## **Resource Consent for Te Rauone Beach Management Scheme: Coastal Process Effects Review**

Port Otago have submitted a resource consent application for a beach management scheme at Te Rauone Beach that includes the construction of three rock groynes and the placement of dredged sand. The consent application is supported by an AEE prepared by GHD Ltd. with specialist reports from Beca.

On behalf of Otago Regional Council, Hilary Lennox commissioned Tonkin + Taylor to do a coastal process effects review of the relevant parts of the application for you as our client. This assessment was carried out by Richard Reinen-Hamill, our technical director; coastal engineering and this report sets out our findings and recommendations.

Figure 2 Red dashed "conventional geotextile wrapped core alternative"

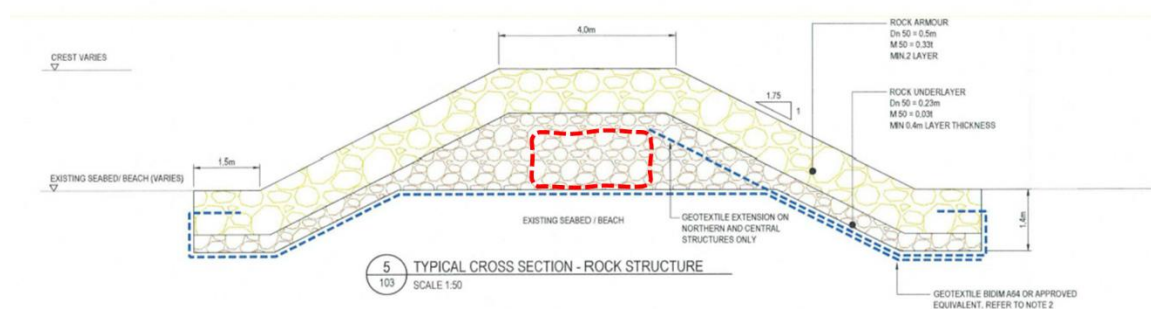
armour layer to assist in reducing sand migration. I note this detail could be improved by a more conventional geotextile wrap around the core of the rock armour (see Figure 2). The toe burial depth, crest and slopes seem appropriate. However, the toe detail on the long sections of sheet 3331121-CA-104 does not seem to match the cross-section details on 3331121-CA-105.
